SCEGGS Darlinghurst

Existing stage road safety audit

Report No TRF-PROJ-0034-01 ES RSA SCEGGS REV 3

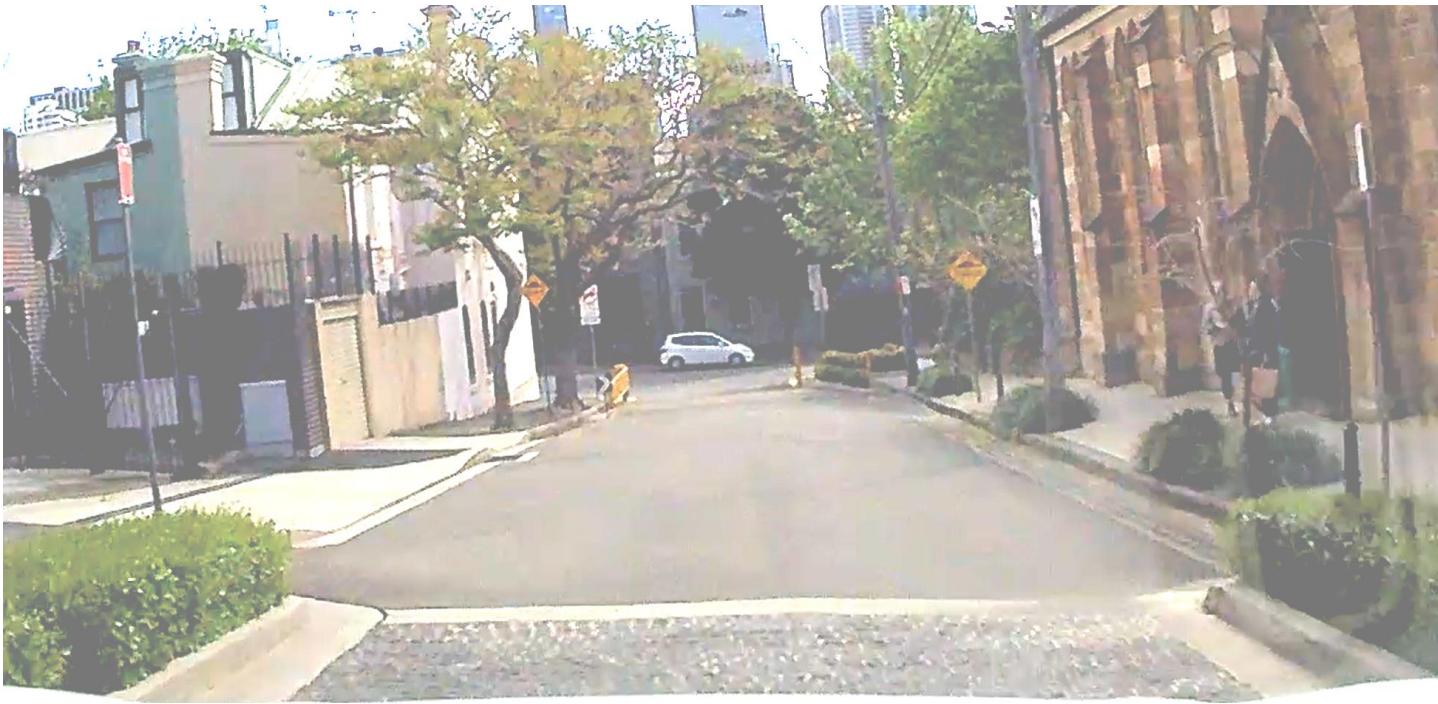
| Ref | Location | Road safety audit finding | Priority |
|-----|--|--|----------|
| 2 | Vehicular gate to the school from Forbes Street. | <p>There is a vehicular access to the school on the western side of Forbes Street. However, as shown there is limited visibility between any outbound driver from the driveway and pedestrians on the footpath approaching from either direction. The main sight-obstructing features are the hedges and brick walls either side of the driveway. This could present risks of <i>vehicle-pedestrian</i> crashes.</p>  <p>Left: Looking north along the western footpath of Forbes Street showing the lack of mutual sight line between a pedestrian facing in this direction, and any egressing driver/ vehicle from this gate. Right: A similar visibility constraint for a southbound pedestrian approaching from the north.</p> | High |
